Proposal to Reduce ring-ing of AHS in Elburn
9-1-09

WEST ELBURN
GENEVA SUB.
M.P.43.81
SW.3
SIGNALS 1W, 2W
8'X14' VHLC SLAVE HOUSE

CLBURN, ILLINOIS
HWY 47
M.P. 43.94
GENEVA SUBDIVISION
D.O.T.#175 009V
~~*PROJ.#~~

DATE 05-03-01
SHEET 1
DWG 43.81
GEN

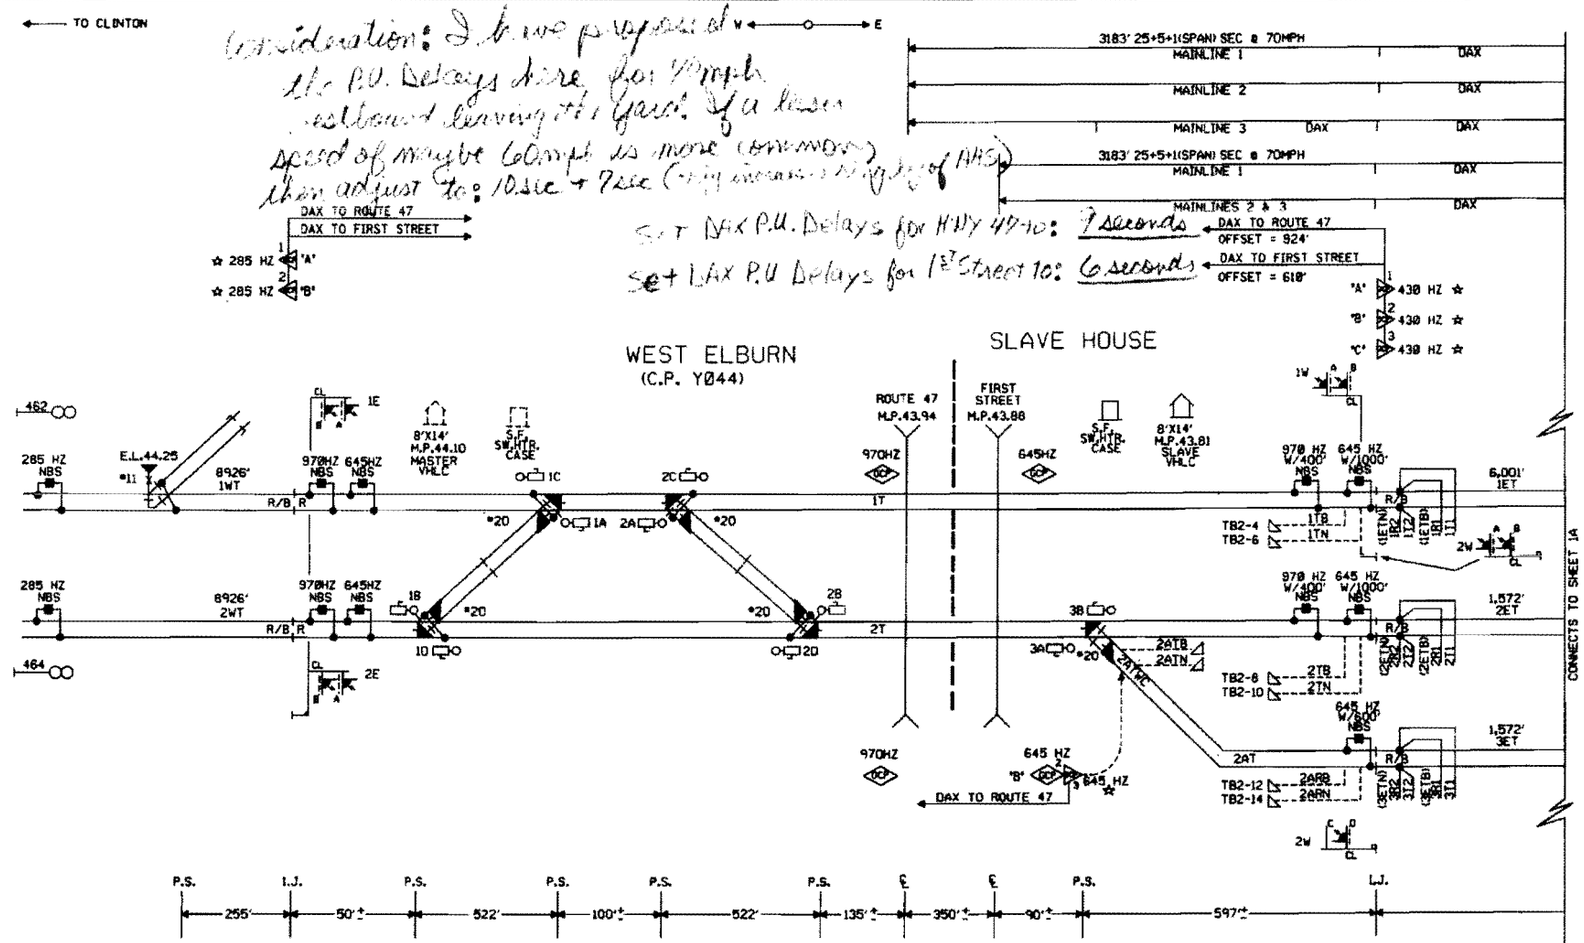
Consideration: I have proposed the P.U. Delays here for 70mph eastbound leaving the yard. If a lesser speed of maybe 60mph is more common then adjust to: 10sec + 7sec (only increase length of AHS)

Set DAX P.U. Delays for HWY 47-10: 7 seconds

Set LAX P.U. Delays for 1st Street to: 6 seconds

DATE 05 03 01
SHEET 1A
DWG 43.94
GEN

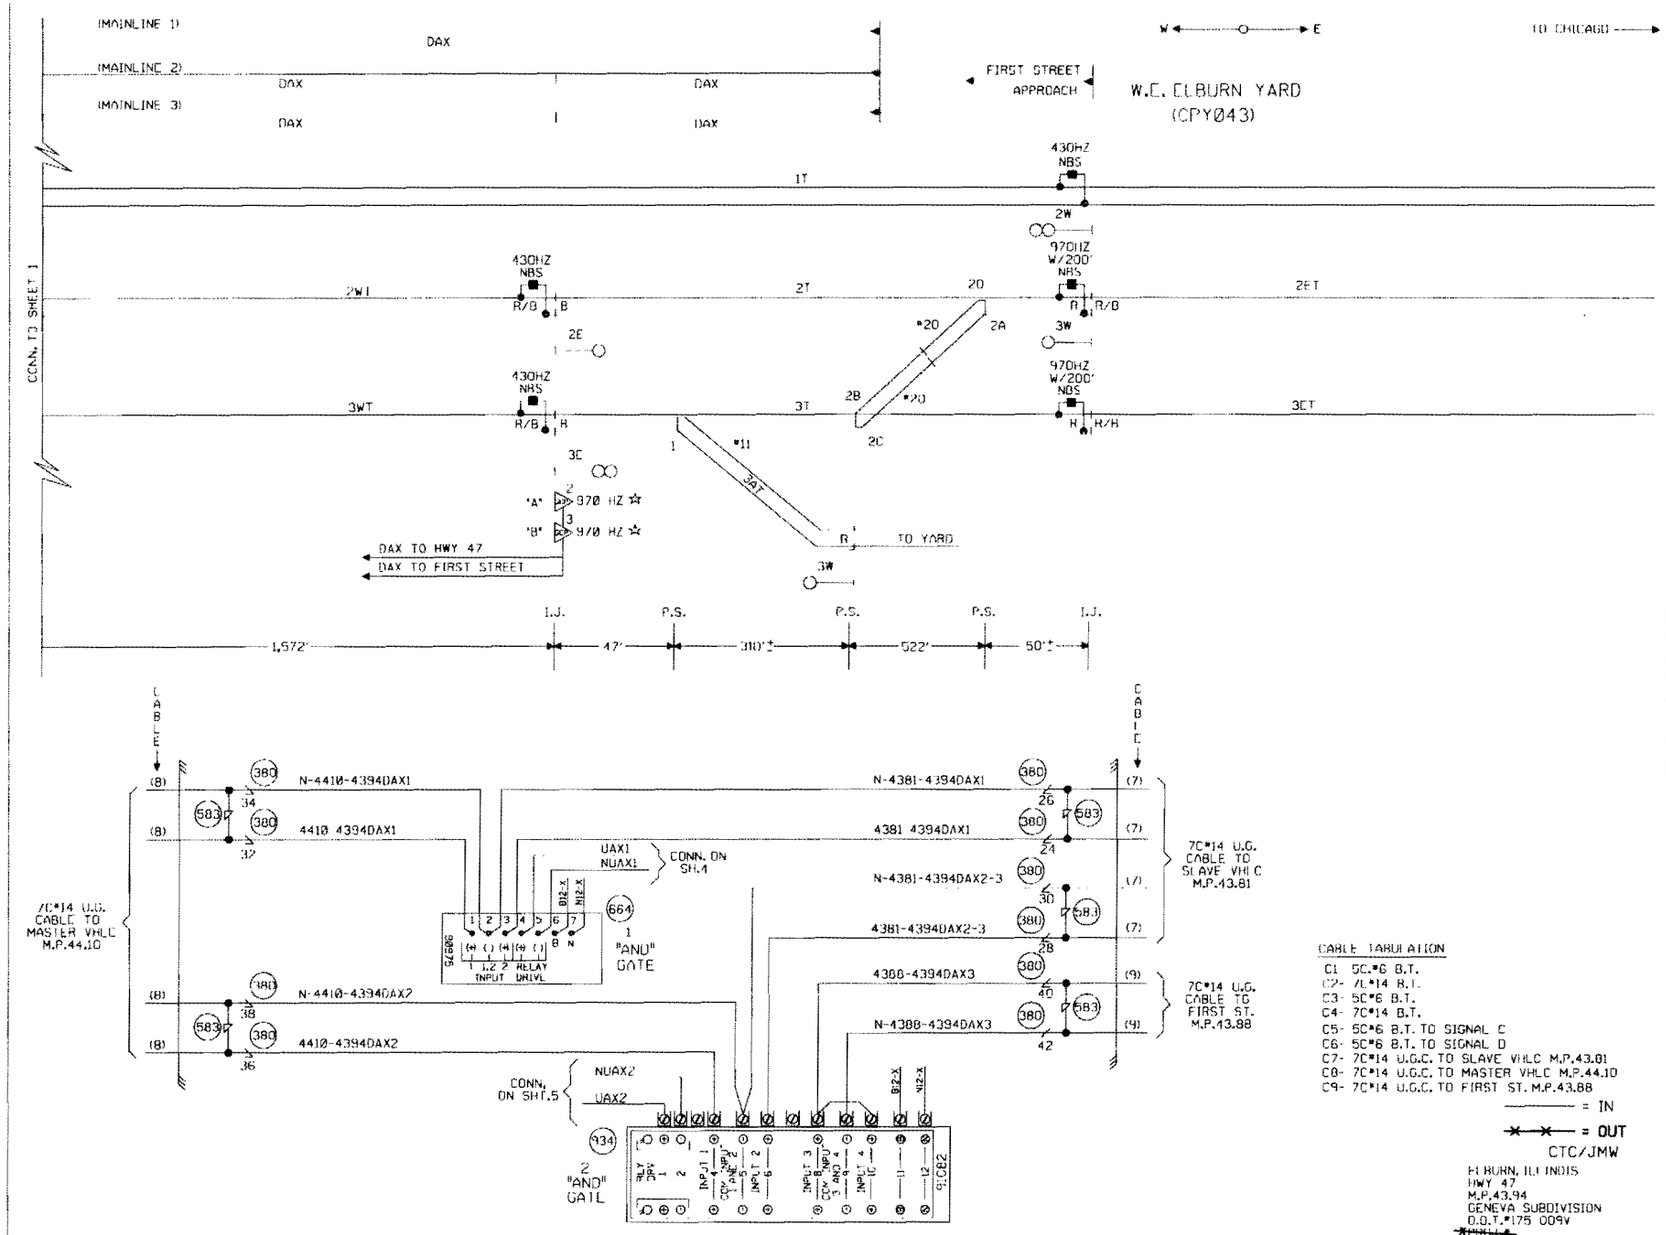
Note: Program DAX A to provide:
1-foot offset
and 5 sec P.U. Delay

Proposal to Reduce susp by of AHS in Clinton

Restore original AND gate for XR
